Access Compliance Report

Public Rights-of-Way

Intersection ID: 18058	Main Street: COLONY_RD	Cross Street: ROSWELL_AV	Location:	NE
ADA ID: 3ADDDDB5EB473	Ramp Type: PerpDiag	Initial Pass/Fail: Fail	Overall Compliance: No	Severity Score: 25
Codes/Mitigation Info/Possible Solution		Field Measurements/Component Compliance

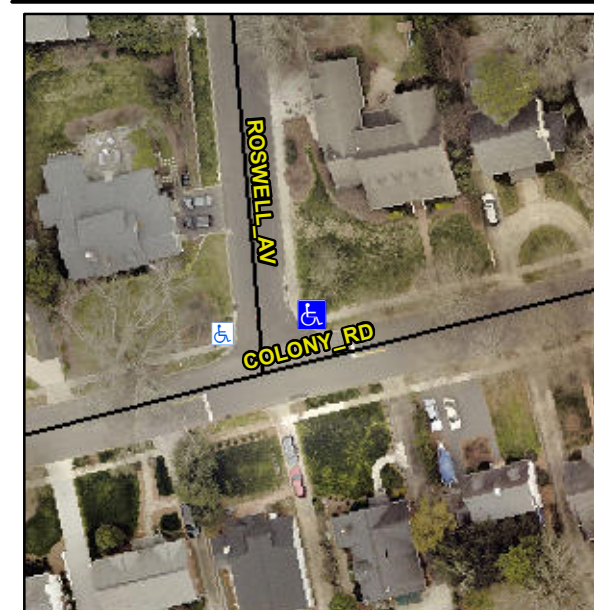
Not Found, R304.5.3

Compliance	Description	Data	Compliance	Description	Data
N/A	Ramp Length (in)	59.0	Yes	Ramp Slope (%)	7.6
Yes	Ramp Width (in)	48.0	No	Ramp XSlope (%)	8.0
N/A	Flare Type LT	N/A	N/A	Flare Type RT	N/A
N/A	Flare Slope LT (%)	N/A	N/A	Flare Slope RT (%)	N/A
N/A	Flare Traversable LT?	N/A	N/A	Flare Traversable RT?	N/A
N/A	Landing Length (in)	N/A	N/A	DWS Provided?	N/A
N/A	Landing Width (in)	N/A	N/A	DWS Contrast?	N/A
N/A	Landing Slope (%)	N/A	N/A	DWS Length (in)	N/A
N/A	Landing X Slope (%)	N/A	N/A	DWS Full Width?	N/A
N/A	Landing Curb? (Y/N)	N/A	N/A	DWS Offset (in)	N/A
N/A	Shared Landing?	N/A			
N/A	Gutter Ponding?	N/A	N/A	Gutter Slope (%)	N/A
N/A	Gutter Lip Ht (in)	N/A	N/A	Gutter X Slope (%)	N/A
N/A	Painted X Walk1?	No	N/A	Painted X Walk2?	No
	X Walk 1 Direction	To W		X Walk 2 Direction	To S
N/A	X Walk 1 Width (in)	N/A	N/A	X Walk 2 Width (in)	N/A
	X Walk 1 Slope (%)	5.3		X Walk 2 Slope (%)	2.0
	X Walk 1 X Slope (%)	8.7		X Walk 2 X Slope (%)	4.4

Remove & Replace Curb Ramp With Two New Directional Ramps or Equivalent.
